“Concept F – Refined”

Introduction

Schematic plan view of road widths at specified points along Franklin Street (left) and South Broadway (right)

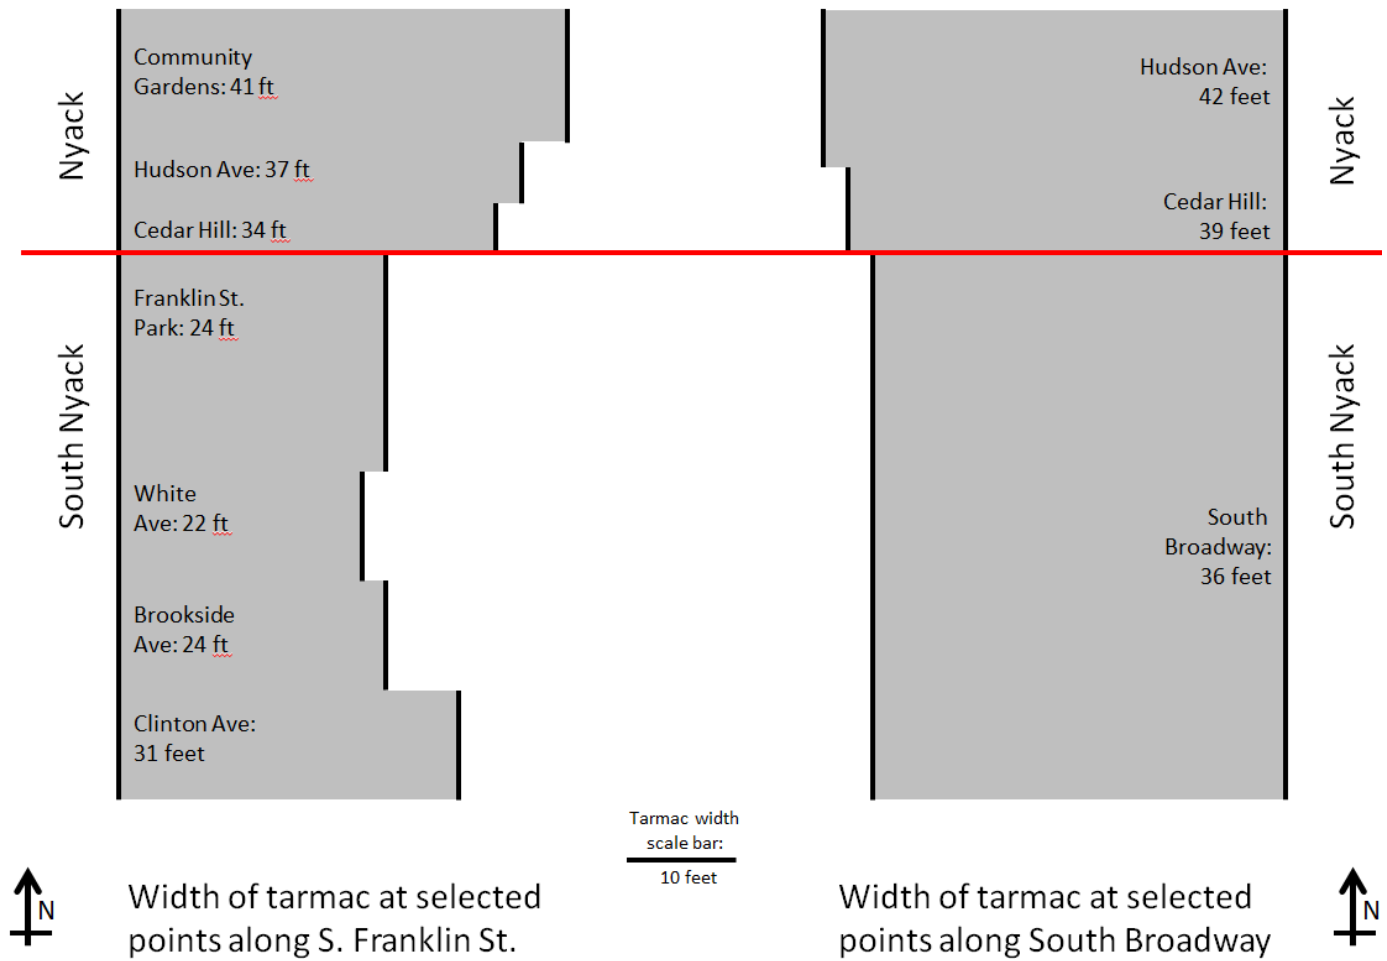
Original Concept F directs SUP cyclists from the Esposito Trail onto Franklin Street. The Village would need to undertake measures to ensure their safety. To accommodate SUP cyclists between Clinton Avenue and Cedar Hill Avenue, most of Franklin Street would need to be widened so that bike lanes could be added.

The cost of widening Franklin Street would likely be borne by Village taxpayers. Regardless of funding, it would demand major construction work and retaining walls along the Esposito Trail between Clinton and Cedar Hill. Storm run-off generated by the widened roadway could require additional costly drainage work. Overhead power, cable and telephone lines and an underground fire hydrant line would need to be moved.

Image from New NY Bridge website. Intersection of Esposito Trail and SUP spur ramp at top of stairs near the gazebo. View direction is looking south. Village Hall is visible left of center.

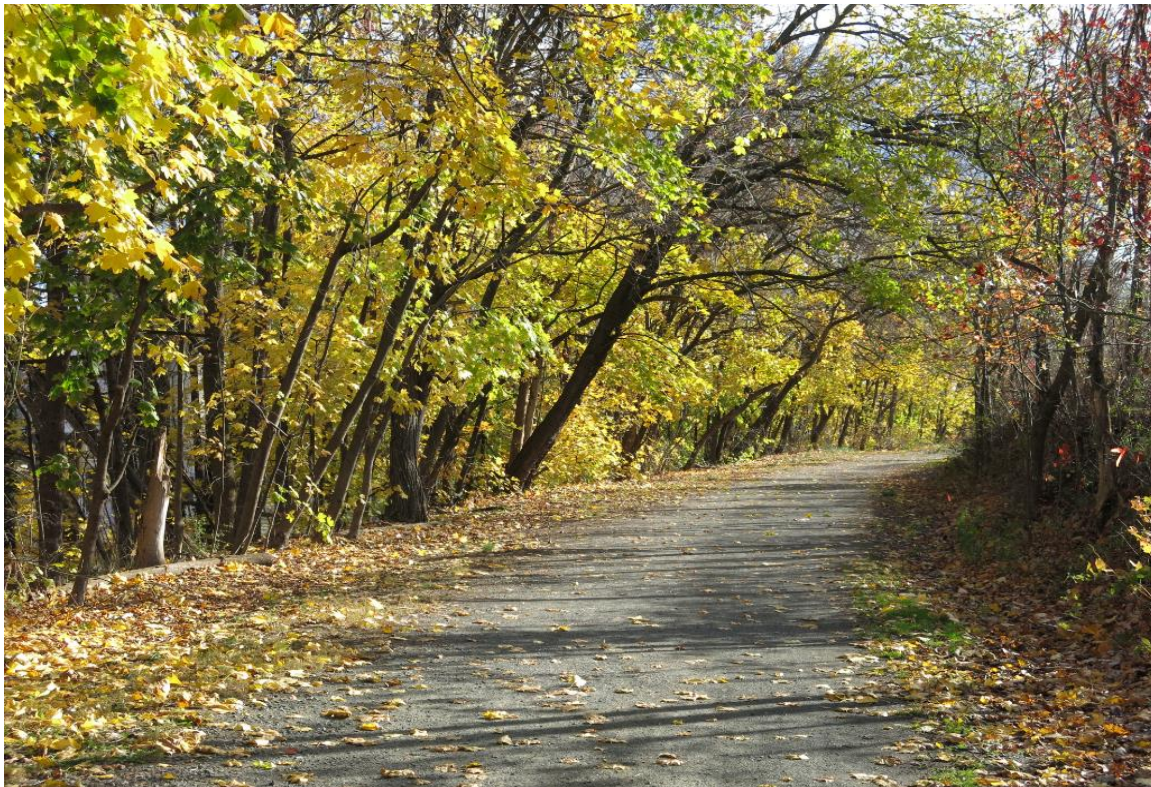
The recently-unveiled urban trail-like scene, below, depicts the Concept F vision for the Esposito Trail near Village Hall, featuring fencing, paving, bollards, lights, and signage. Pedestrians and joggers would need to be extra vigilant at this intersection with the partially-paved Esposito Trail because the irresistible lure of a gently-curved downhill ramp that joins with the main SUP may encourage SUP cyclists to speed here.

The paved Esposito Trail will remain open beyond dusk, potentially until 11pm each night, requiring Village Police vehicles to patrol the fenced-in Esposito Trail and connector ramp. Maintenance-wise, DPW could be burdened with keeping the paved Esposito Trail and the connector ramp free of leaves, ice and snow. Also, use of rock-hard granite dividers may lead to persistent erosion of the adjacent gravel trail.
